## REVISED RESPONSE TO REQUEST FOR ADDITIONAL INFORMATION

### APR1400 Design Certification

Docket No. 52-046

**RAI No.:** 252-8299  
**SRP Section:** 03.07.02 – Seismic System Analysis  
**Application Section:** 3.7.2  
**Date of RAI Issue:** 10/19/2015

Figure 26. Comparison of Transfer Functions of 9458 Node at Basemat Bottom Elevation (S1 Soil Profile, Cracked Concrete Stiffness Case)

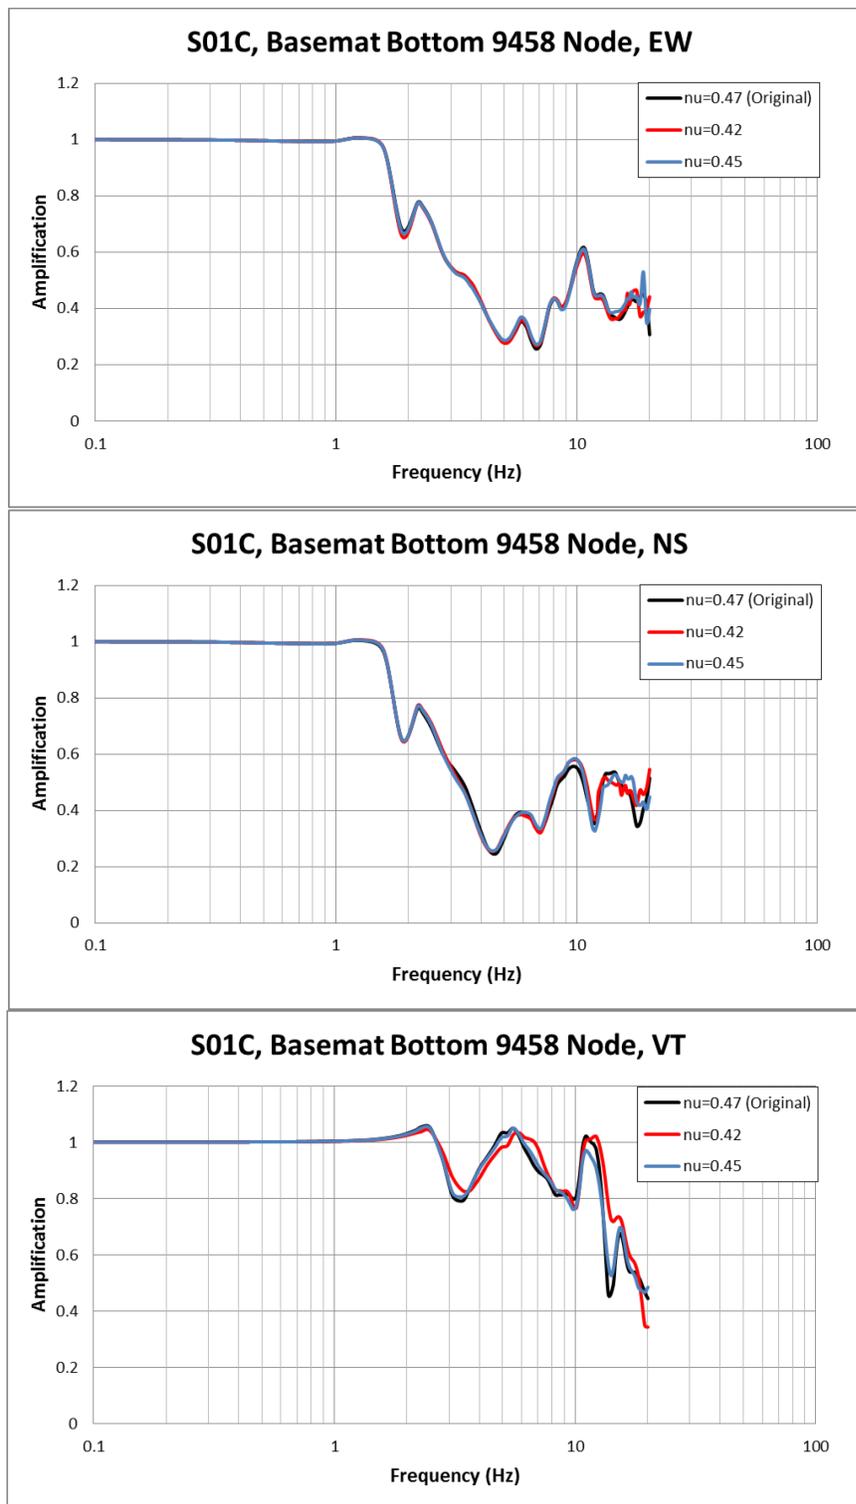
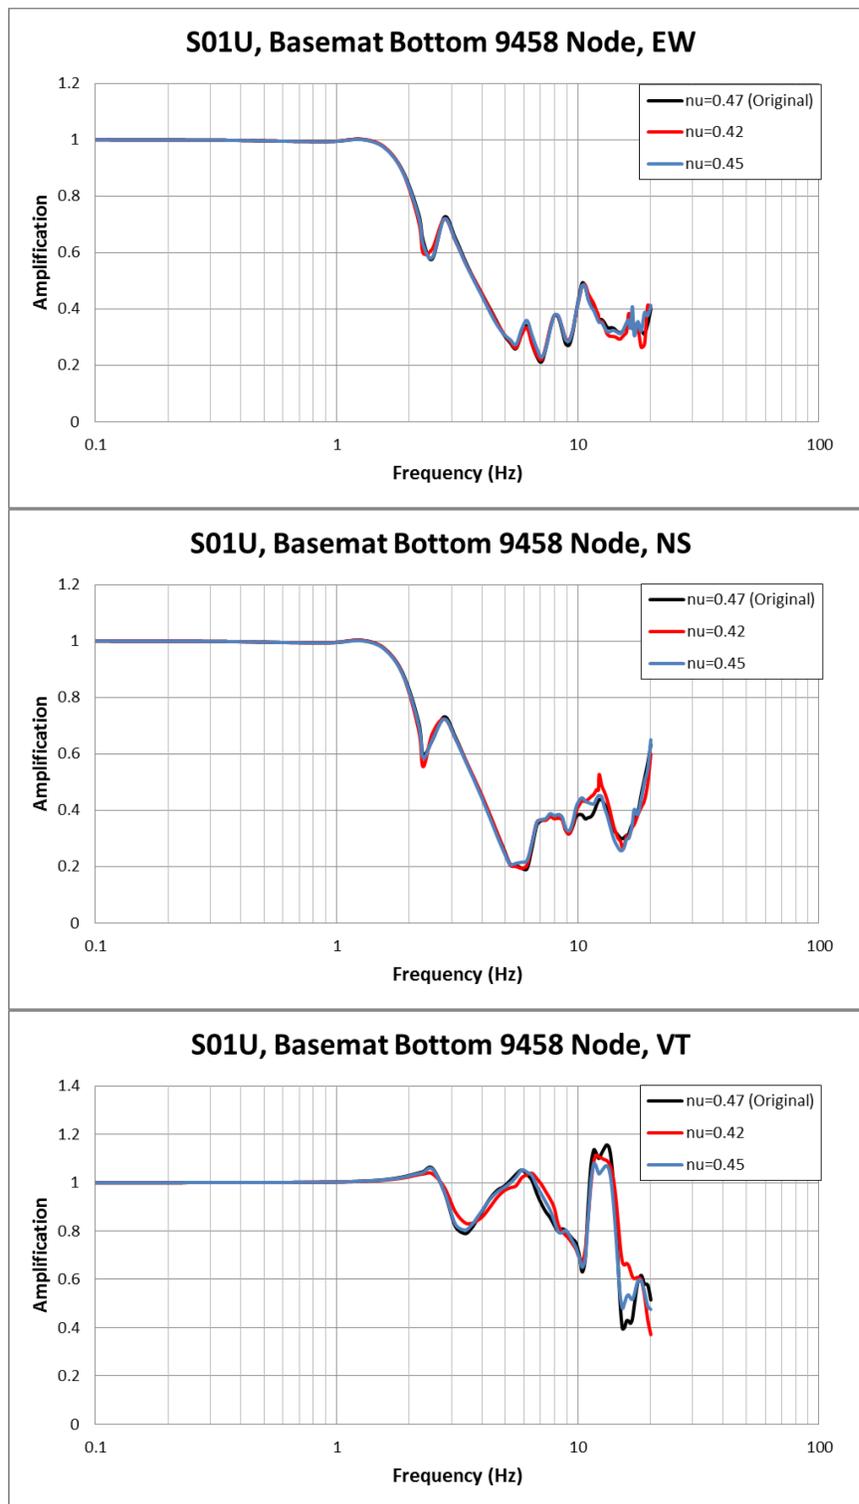
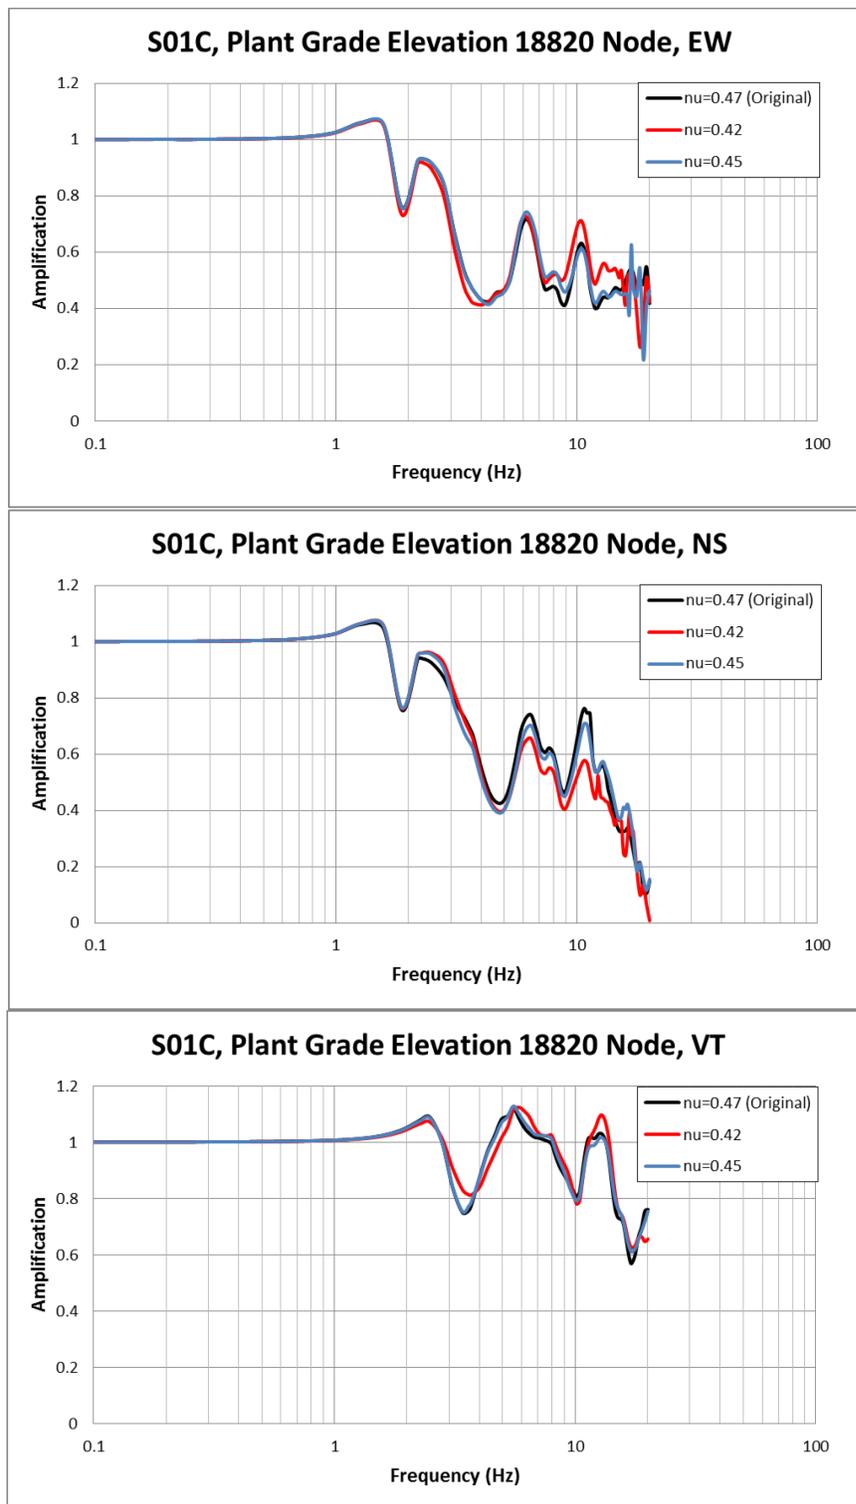
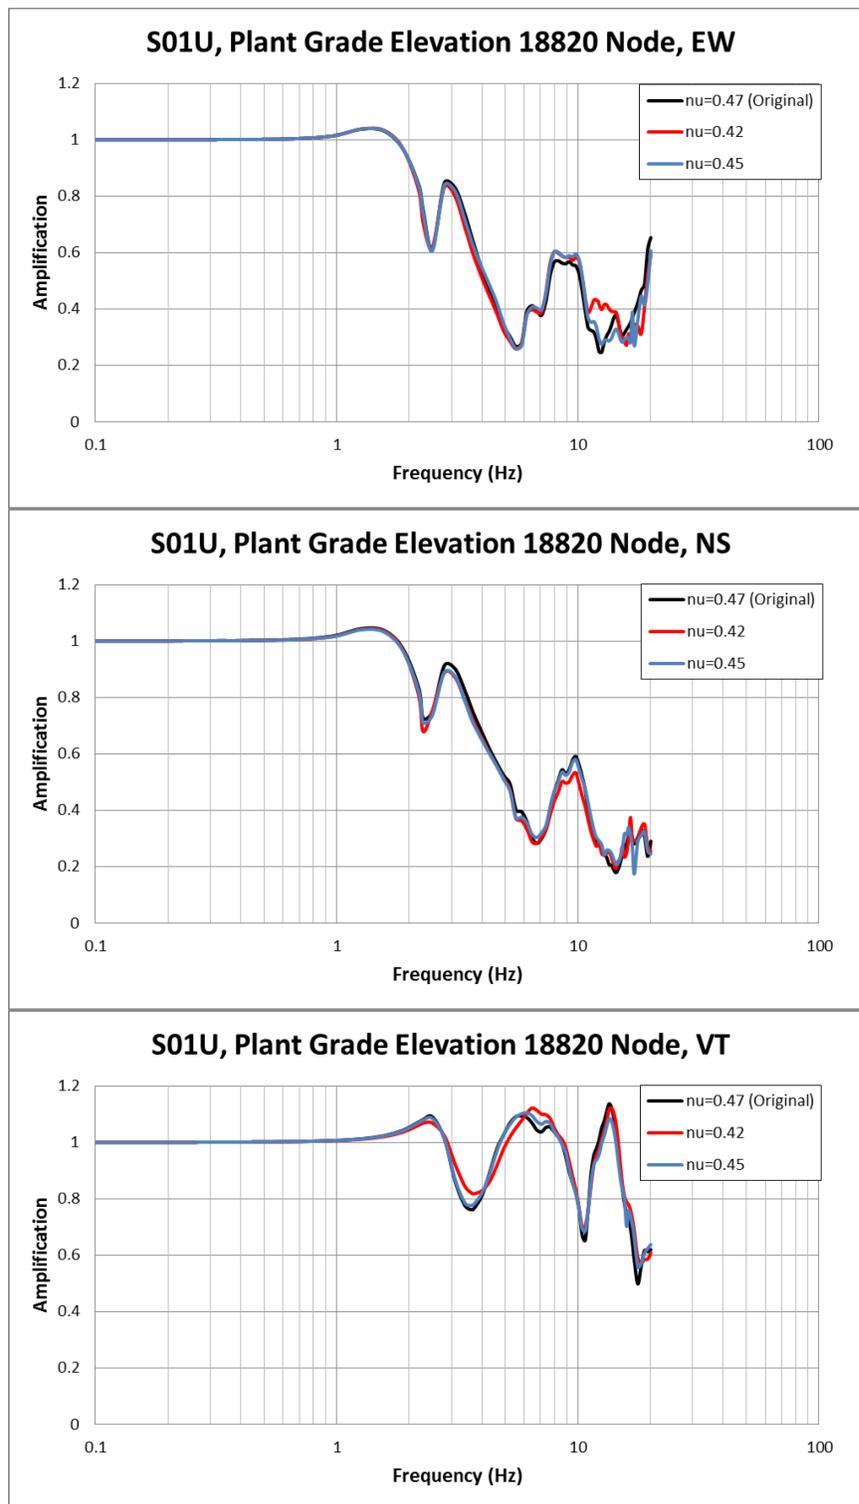
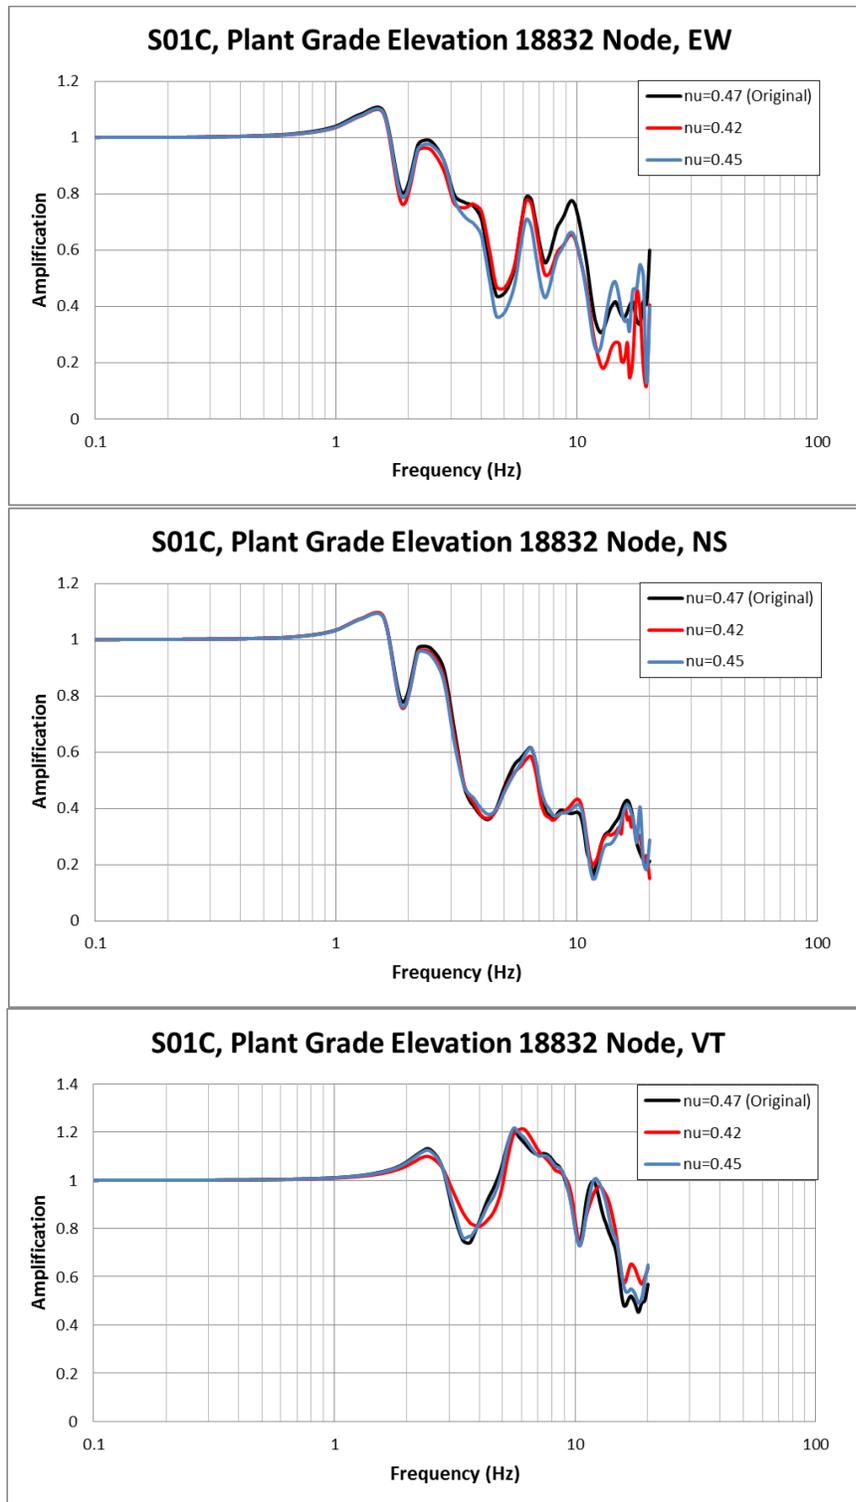
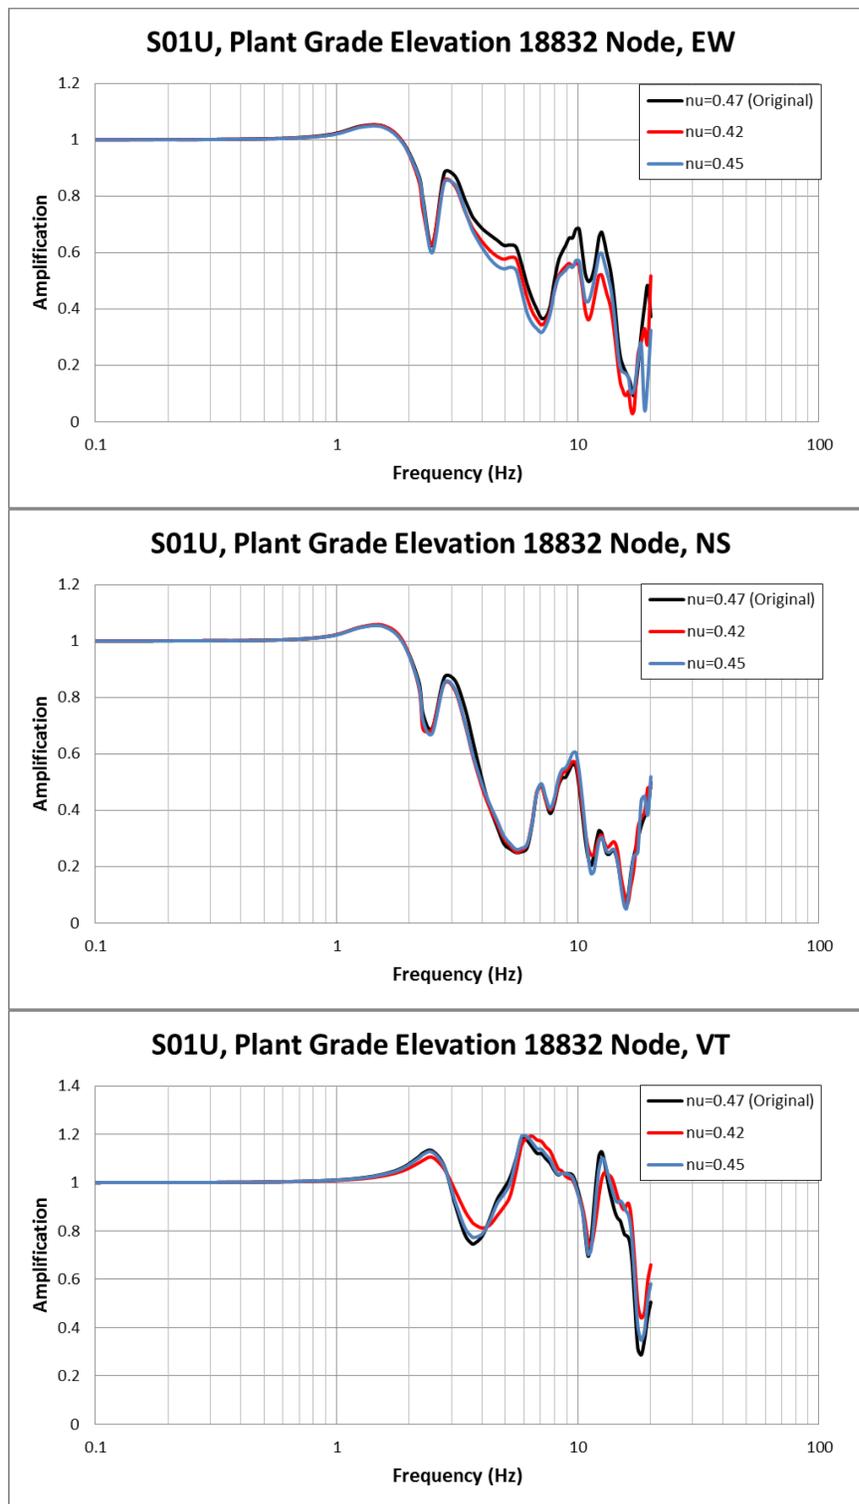
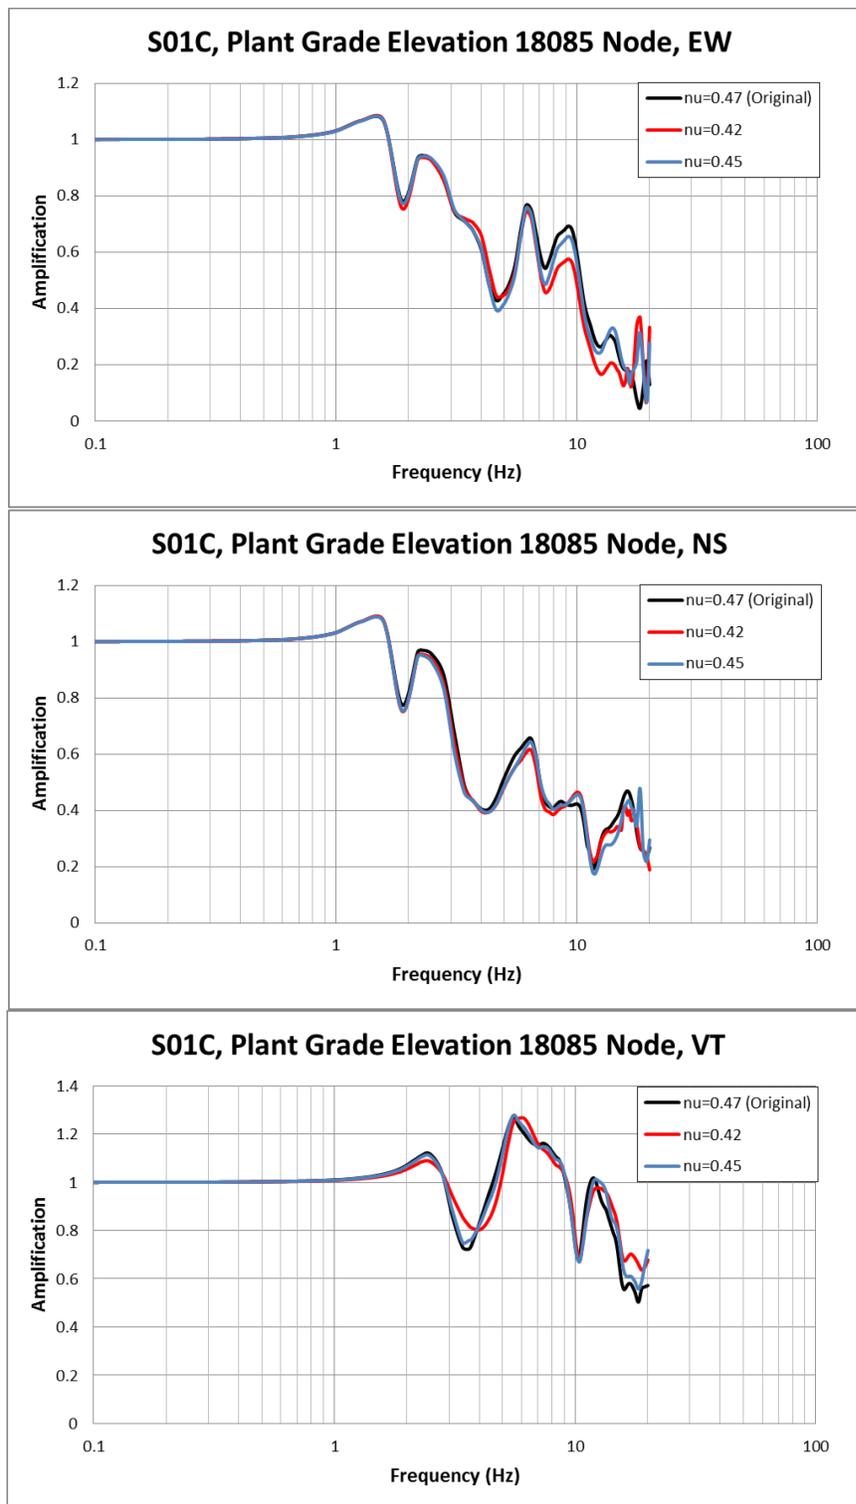
e) Poisson's Ratio Used in SSI Analyses

DCD Tables 3.7A-1 and 3.7A-2 show Poisson's ratios in the S1 and S2 soil profiles used for SSI analysis as great as 0.47 and 0.48 respectively. Based on staff experience, use of Poisson's ratio approaching these values may result in numerical instability of the SSI analysis results. Therefore, to assist the staff in evaluating the adequacy of the SSI analysis results based on the aforementioned soil profiles, the staff request the applicant to provide a demonstration (e.g. sensitivity study) that the assumed Poisson's ratio values do not produce numerical instabilities in the SSI results based on these profiles.

Using the modified soil profiles of S1 and S2, SSI analyses of NI models of both cracked and uncracked concrete stiffness cases are re-performed. Then, the transfer function results at NI basemat bottom and plant grade elevations obtained from the original SSI analyses and the re-performed SSI analyses in the sensitivity study are compared to judge the existence of numerical instabilities in the original SSI results. The locations of the selected nodes at basemat bottom and plant grade elevations using in the comparisons are provided in Figures 18 and 19. The comparisons of transfer function results for S1 and S2 soil profile cases are presented in Figures 20 through 51.

As shown in the comparisons of transfer functions presented in these figures, the transfer functions obtained from the original SSI analyses are quite similar and comparable to the transfer functions obtained from the sensitivity study re-performed SSI analyses. In addition, no abrupt changes or spurious peaks, which tend to indicate existence of

numerical sensitivities in the SASSI solutions, appear in the computed transfer functions of the original SSI analyses that have the maximum dynamic Poisson's ratio values of 0.47 and 0.48 as well as in the re-computed transfer functions that have the maximum dynamic Poisson's ratio values limited to 0.42 and 0.45. These results demonstrate that there is no numerical instabilities in the original SSI analysis results of the S1 and S2 soil profile cases.
